SERVICE BULLETIN

TORQUE PRESSURE TRANSDUCER HIGH INTENSITY RADIATED FIELDS (HIRF) PROTECTION MODIFICATION

* Supersedes Service Bulletin 600N-018, dated 08 October 1998. Expanded aircraft effectivity to ensure an accurate torque indication system for all affected helicopters and corrected connector part number. Aircraft which have complied with SB600-018 have met the intent of this revision.

Figure 1. Component Locator

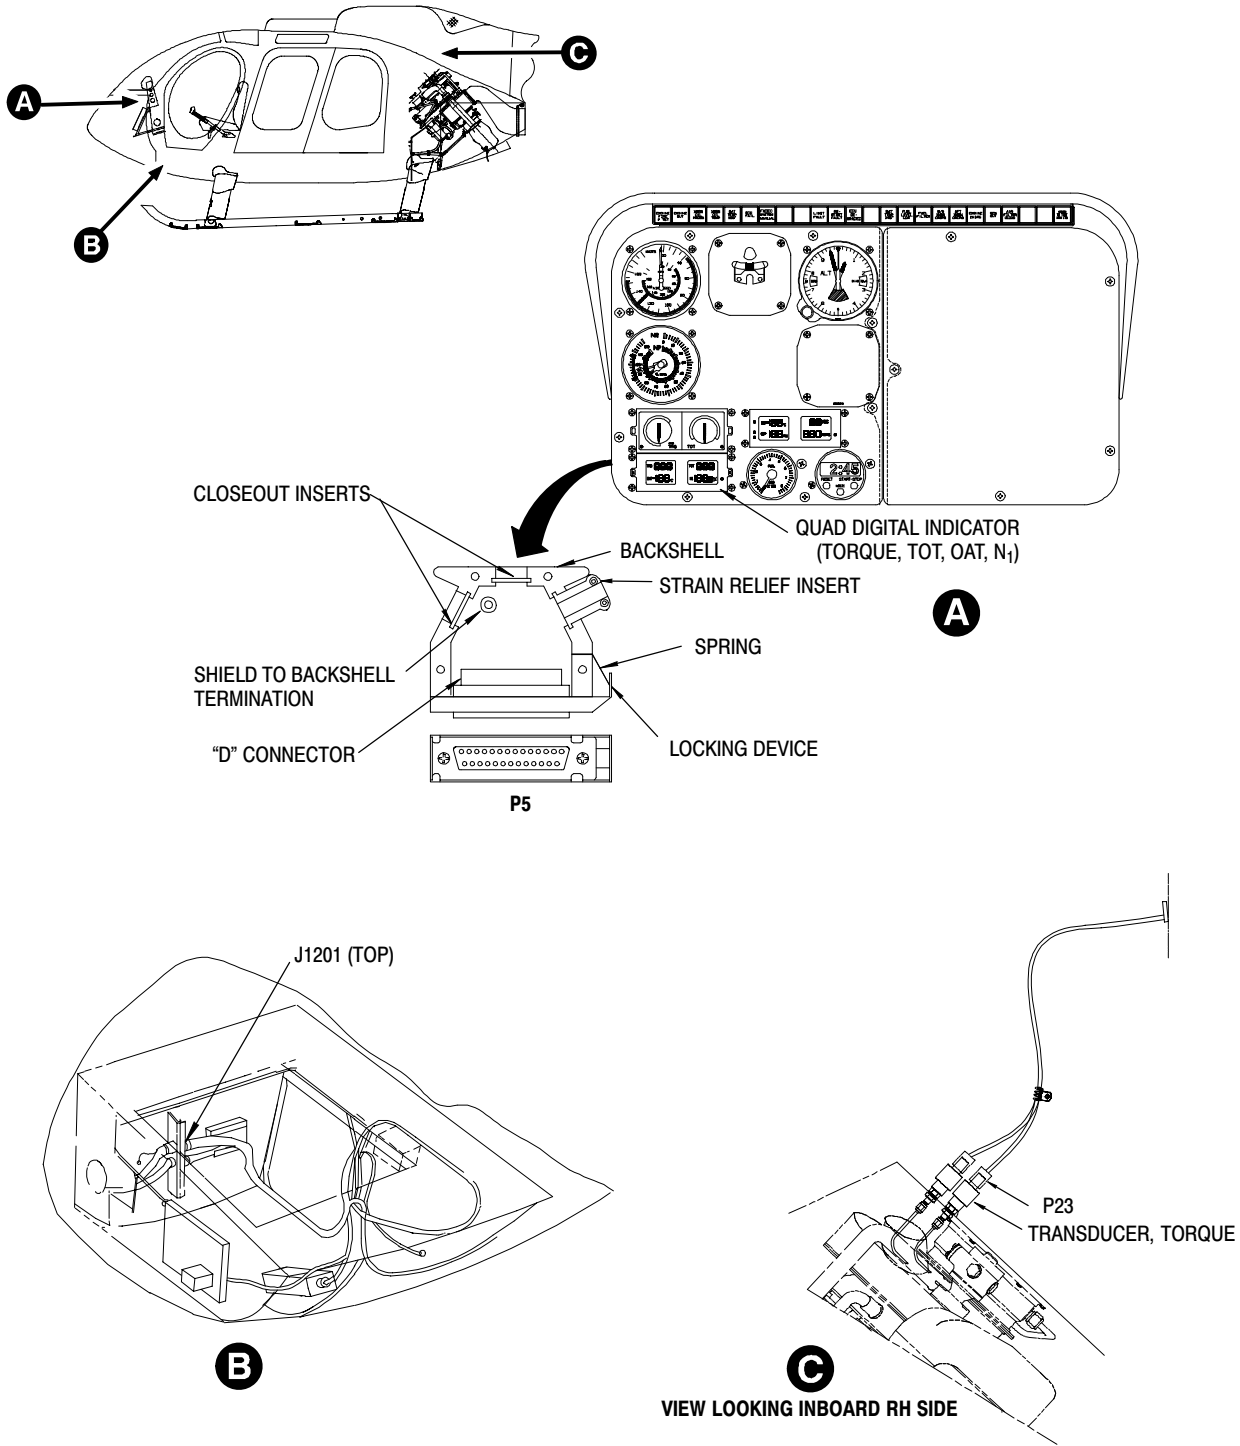
- (1). Disassemble P5 and Install M83519/2-8 shield jumpers onto the shields of P5-3 and P5-4.
- (2). Daisy chain shield jumpers from P5-3, P5-4, and P5-6 together and heat shrink shield sleeves.
- (3). Reassemble P5.
- (4). Close all previously opened access panels.
- (5). Scrap removed parts except transducer which can be retained as a spare engine oil pressure transducer.
- (6). Record compliance to this Service Bulletin in the Compliance Record section of the helicopter Log Book.

Figure 2. Wiring Modification, Torque Pressure Transducer

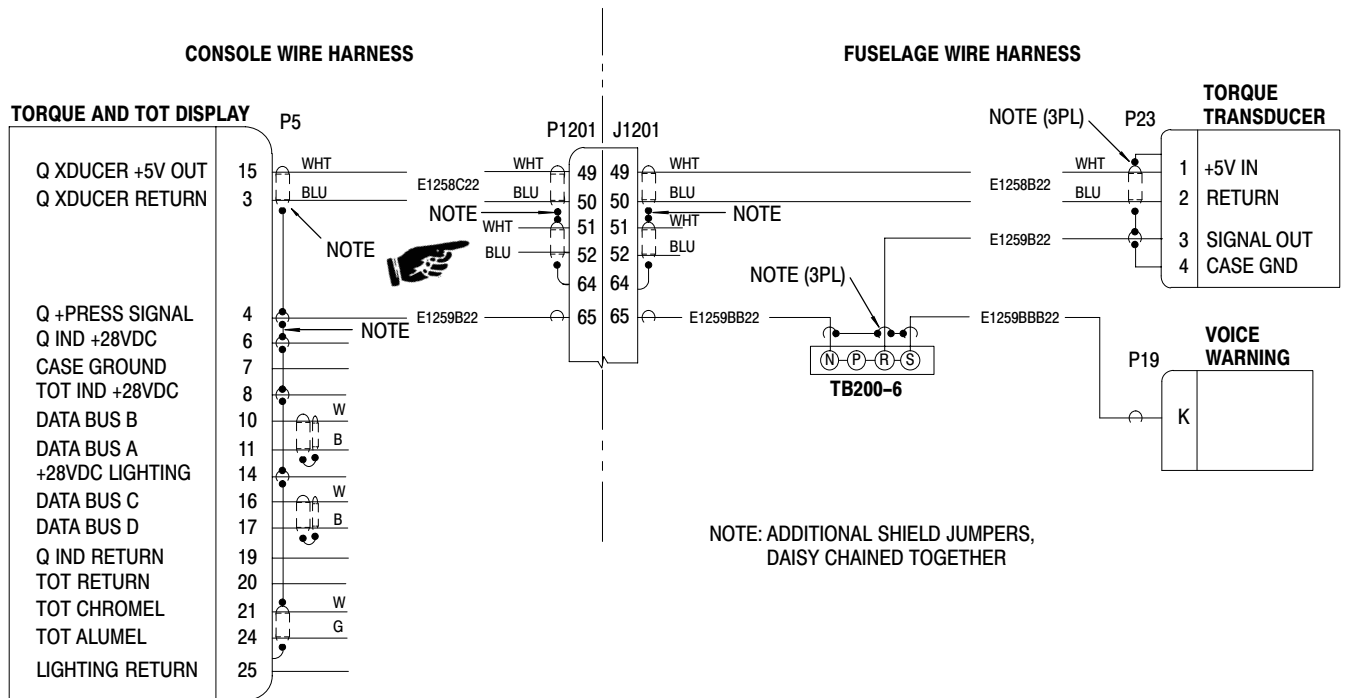
- (1). Access P23 and remove existing connector.
- (2). Cut the shield jumper pigtail from the shield sleeve at J1201-50. Leave the pigtail attached to the shield sleeve at J1201-51.
- (3). Replace existing E1258B22 with M27500-22SD2T23 two conductor shielded wire.
- (4). Replace existing torque pressure transducer P/N PX9606 with new P/N PX10126 torque pressure transducer (Ref. CSP-HMI-2).
- (5). Terminate new E1258B22 with M39029/58-360 (J1201) pins (tool item no.7), M39029/57-354 (P23) sockets (tool item no.8) and install M83519/2-8 shield jumpers.
- (6). At J1201 insert the white wire into J1201-49 and the blue wire into J1201-50.
- (7). Insert jumper from J1201-51 into new shield sleeve at J1201-50 and heat shrink shield sleeve.

- (8). At P23 place M85049/17-08N02 backshell over E1258B22 and shield jumper.
- (9). At P23 insert the white wire into P23-1 and the blue wire into P23-2.

- (10). Replace existing E1259B22 with M27500-22SD1T23 single conductor shielded wire.
- (11). Terminate new E1259B22 with M39029/57-354 (P23) socket (tool item no.8).

- (12). At P23 insert E1259B22 through M85049/17-08N02 backshell.
- (13). At P23 install M83519/2-8 shield jumper onto E1259B22, insert conductor into P23-3 and daisy chain shield jumper with shield of E1258B22.

- (14). Using previously removed 24 AWG single conductor wire, fabricate a shield jumper pigtail of sufficient length to jumper the shield on E1259B22 and P23-4.

- (15). At P23 terminate fabricated shield jumper with M39029/57-354 socket (tool item no.8) and insert into P23-4.
- (16). Insert remaining end of fabricated shield jumper into shield sleeve on E1259B22.

- (17). At P23 ensure all shield jumpers are in place and heat shrink shield sleeves.
- (18). Terminate the shield jumper from E1258B22 into the shield termination area of P23 backshell.

- (19). Terminate new E1259B22 with M39029/22-191 (TB200) socket (tool item no.6) and M83519/2-8 shield jumper.
- (20). Insert E1259B22 into TB200-6-R.
- (21). Replace existing E1259BBB22 with M27500-22SD1T23 single conductor shielded wire.

- (22). Terminate new E1259BBB22 with M39029/22-191 (TB200) socket (tool item no.6) and M39029/32-259 (P19) socket (tool item no.5).

- (23). Install M83519/2-8 shield jumper onto E1259BBB22 at TB200.
- (24). At TB200 insert E1259BBB22 into TB200-6-S.
- (25). At P19 insert E1259BBB22 into P19-K
- (26). Replace existing E1259BB22 with M27500-22SD1T23 single conductor shielded wire.
- (27). Terminate new E1259BB22 with M39029/22-191 (TB200) socket (tool item no.6) and M39029/58-360 (J1201) pin (tool item no.7).

- (28). Install M83519/2-8 shield jumper onto E1259BB22 at TB200.
- (29). At TB200 insert E1259BB22 into TB200-6-N.
- (30). At J1201 insert E1259BB22 into J1201-65
- (31). At TB200 ensure shield jumpers from TB200-6-S, R, and N are daisy chained together and heat shrink shield sleeves.
